**Design Review Board Case #2018-0005**  
**Carlyle Plaza Two – South Residential Building**

Application	General Data	
<p><b>Project Name:</b> Carlyle Plaza Two – South Residential Building</p> <p><b>Location:</b> 800 Bartholomew Street</p> <p><b>Applicant:</b> Alder Branch Realty Limited Partnership, LLLP; represented by JM Zell Partners</p> <p><b>Architect:</b> Arquitectonica</p>	<b>DRB Date:</b>	July 19, 2018
	<b>Site Area:</b>	1.28 acres
	<b>Zone:</b>	CDD#11
	<b>Proposed Use:</b>	Residential
	<b>Dwelling Units:</b>	368 units
	<b>Gross Floor Area:</b>	363,222 sf
<b>Purpose of Application:</b>		
DRB review of brick wall detail and setback for the low-rise liner units on the west elevation proposed with the first phase of the Carlyle Plaza Two development.		
<p><b>Staff Reviewers:</b> Robert Kerns, AICP, <a href="mailto:robert.kerns@alexandriava.gov">robert.kerns@alexandriava.gov</a>  Thomas H. Canfield, AIA, <a href="mailto:tom.canfield@alexandriava.gov">tom.canfield@alexandriava.gov</a>  Nathan Imm <a href="mailto:nathan.imm@alexandriava.gov">nathan.imm@alexandriava.gov</a>  Bill Cook, AICP <a href="mailto:william.cook@alexandriava.gov">william.cook@alexandriava.gov</a></p>

**Figure 1 - Building Elevations Comparison**

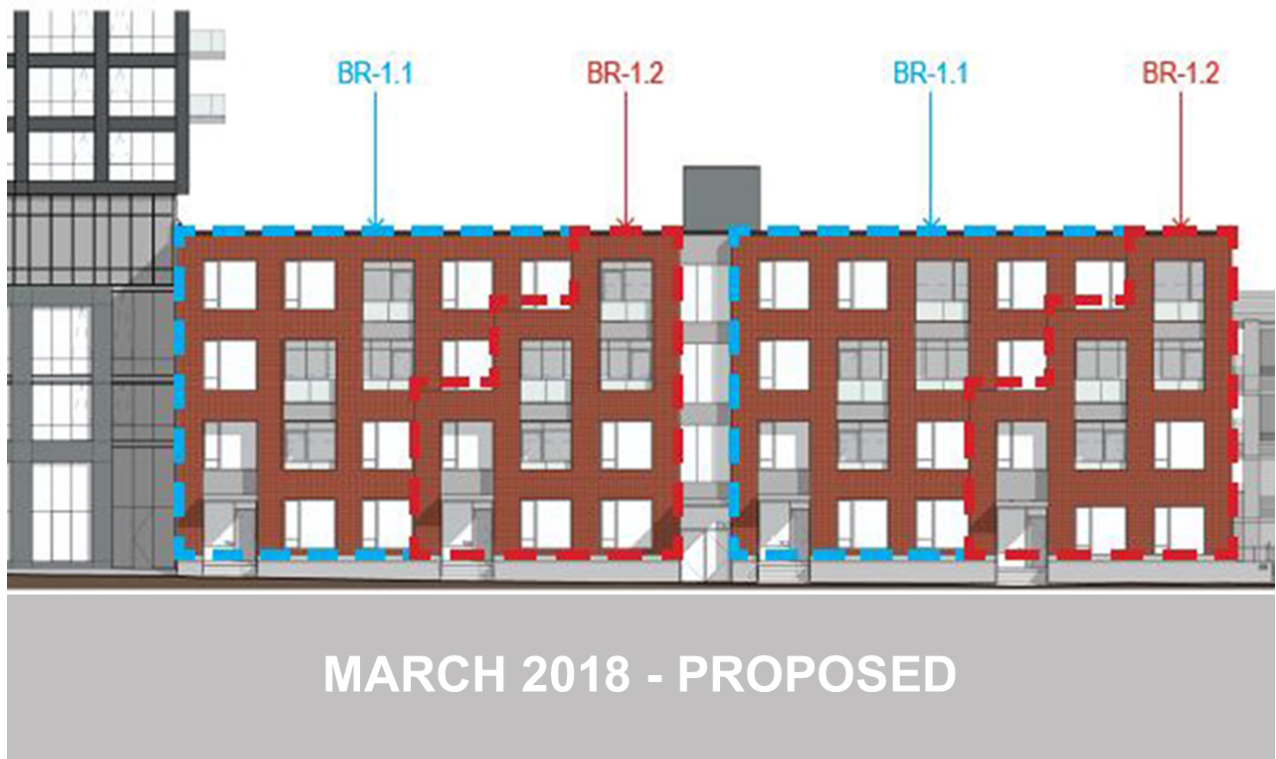
The primary, west-facing, façade of the low-rise liner units is comprised of two planes defined by an offset between the face of the building materials. The front plane forms a series of steps that cascade across this façade providing both horizontal and vertical movement that relates to the cascading effect of the glazing pattern proposed on the South Residential Tower (Figure 1).

The originally approved (July 2016) west façade employed a design strategy that highlighted the contrast between the front, stepped masonry plane and the secondary surface beyond, with additional contrast provided by a shift from a vertical brick pattern in front to a horizontal pattern in the rear. The conditionally approved March 2018 façade has a horizontal brick pattern on both planes, but with different brick sizes on each plane.

While Staff finds the original concept providing a stronger and more elegant contrast between the planes, the proposed revision with an 8 ½ inch depth satisfies the condition of the March 2018 DRB approval and returns some of the strength and clarity of the original design. Staff recommends DRB **approval** of the proposed wall design.

**Figure 2 – Building Elevations Depth Comparison**

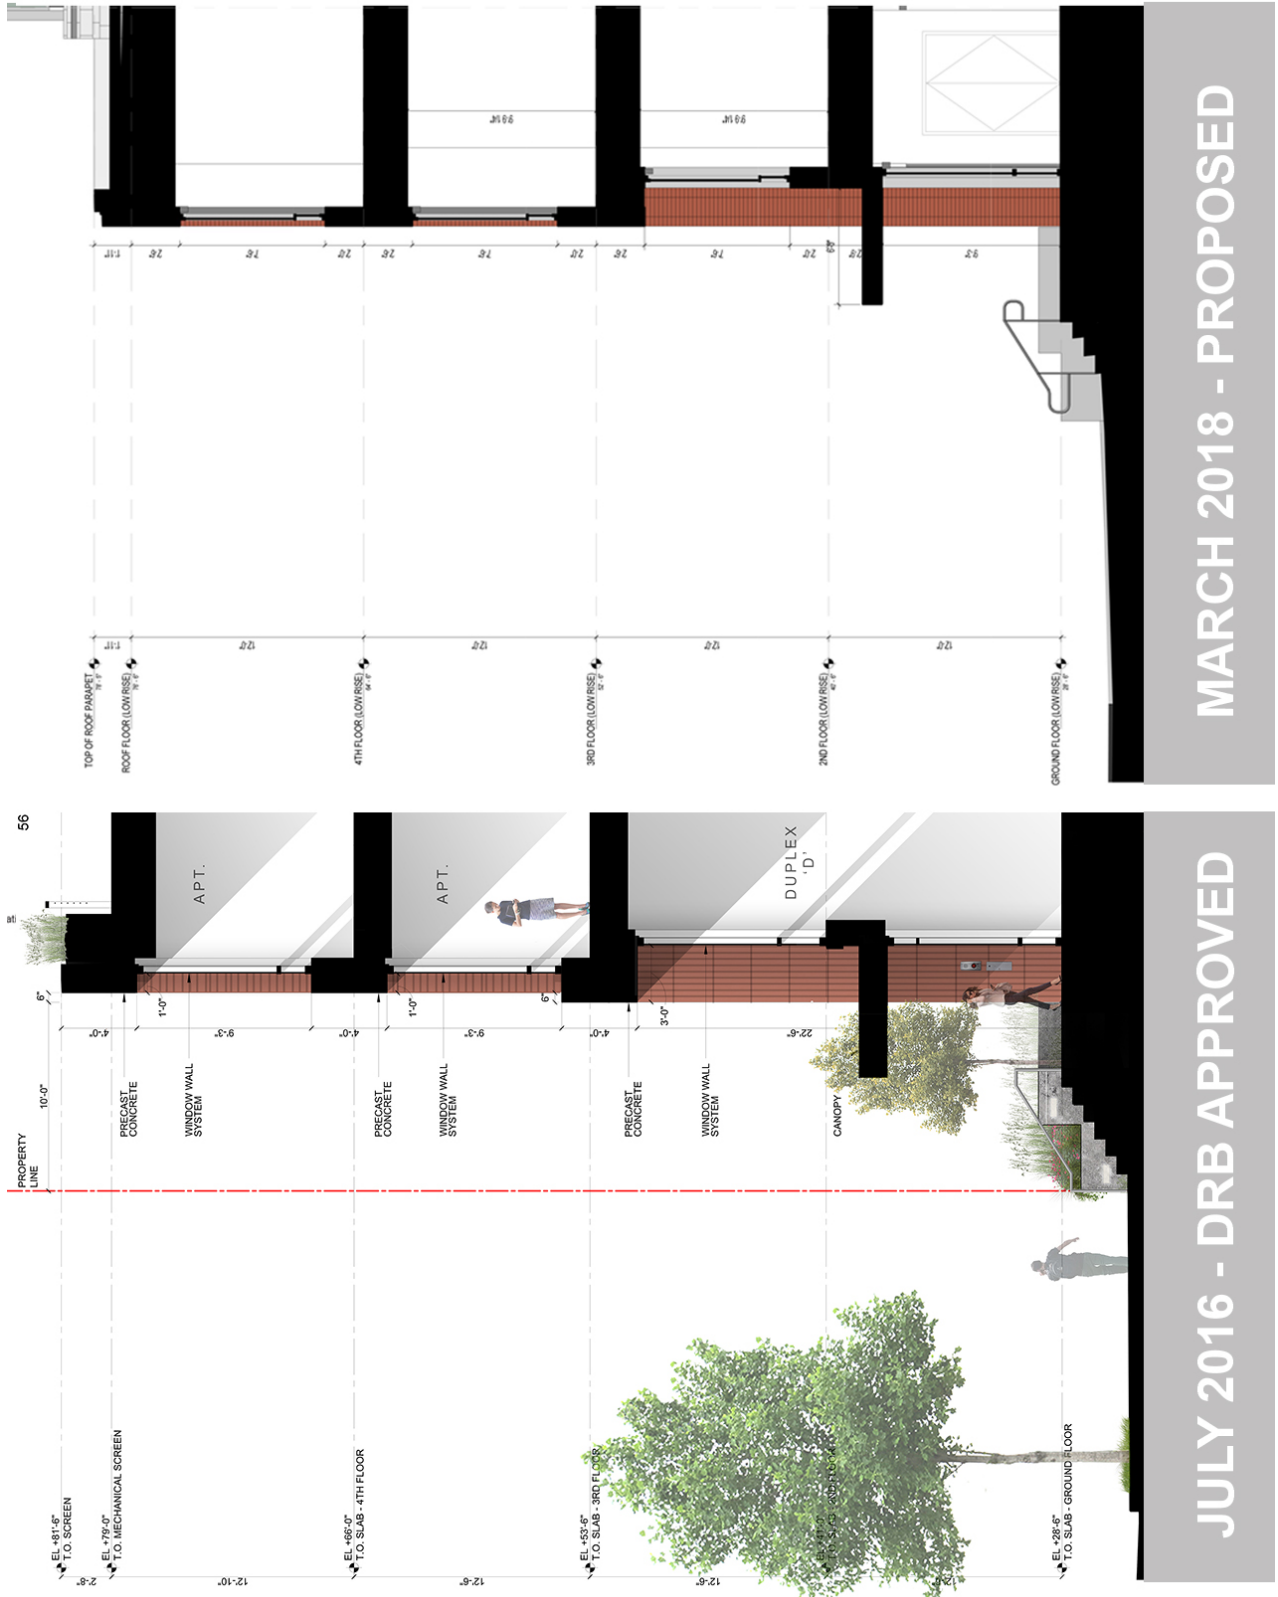
As represented in Figure 2, a 6-inch depth between the front and back planes was proposed in the concept presented to the DRB in July 2016. At that time, the Board approved of the design with the condition that this depth be increased to 12 to 16 inches between the front and back planes. The March 2018 proposed design appeared to measure to a depth of approximately one (1) inch, significantly less than the depth stipulated in the DRB's approval.

As a condition of the March 2018 approval, the DRB directed the applicant to provide Staff and the Board with an additional option that maximizes the depth between the front and back planes to achieve a depth noticeably greater than one (1) inch, with a goal of achieving between 4 to 8 inches.

The applicant has submitted a wall section and detail drawing that shows an 8 ½ inch depth between the front and back planes. The horizontal detail includes a coping stone atop the front plane element with score lines in the edge to match with adjacent brick joints.
